Data Set Name: abyss.tahiti-20221023-asset_labelling-md-tls
Subject: Most Frequent Errors

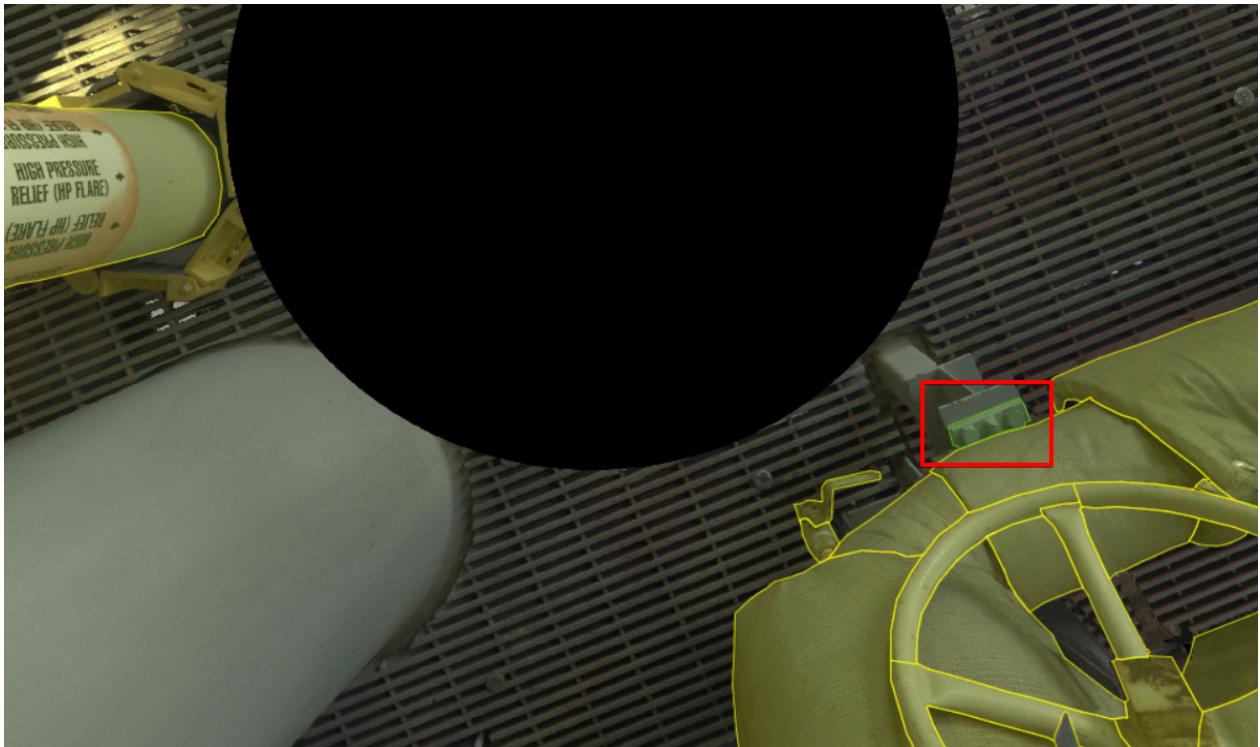
Bridles: Vertical parts of bridles (red boxes) are supposed to be labeled as vessels.

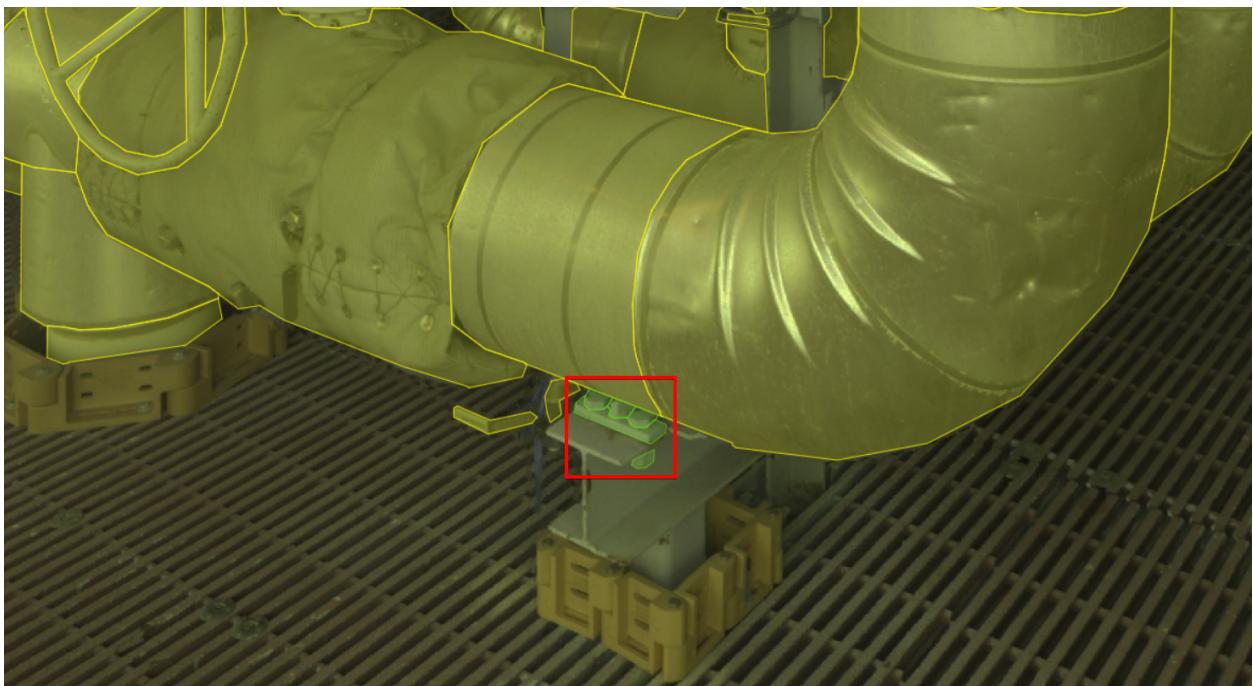
Victaulic Coupling: Should be labeled as a line, as it is used to connect 2 pipes and not to support them.

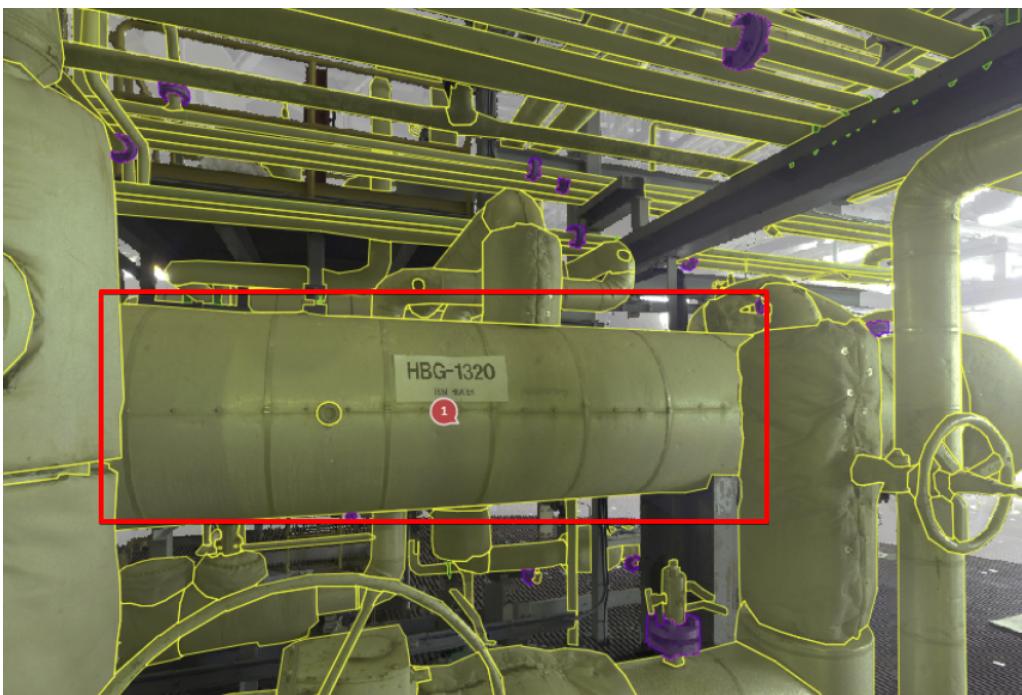
Pipe Supports: Only U-Supports, Dummy Legs, and Spring Pipe Supports should be classified as pipe supports. In this case (the red box) should not be labeled.

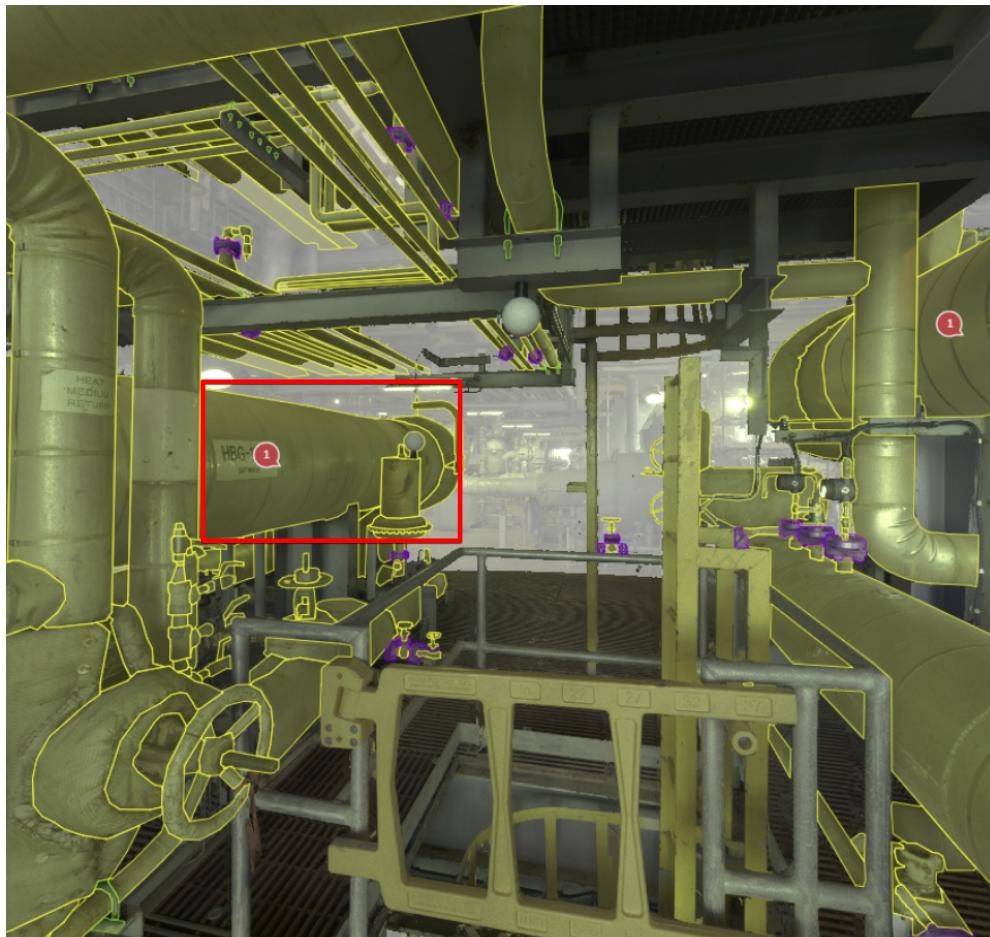
Vessels: Shell and tube heat exchangers (red box) were labeled as lines in multiple images, they should have been classified as vessels.
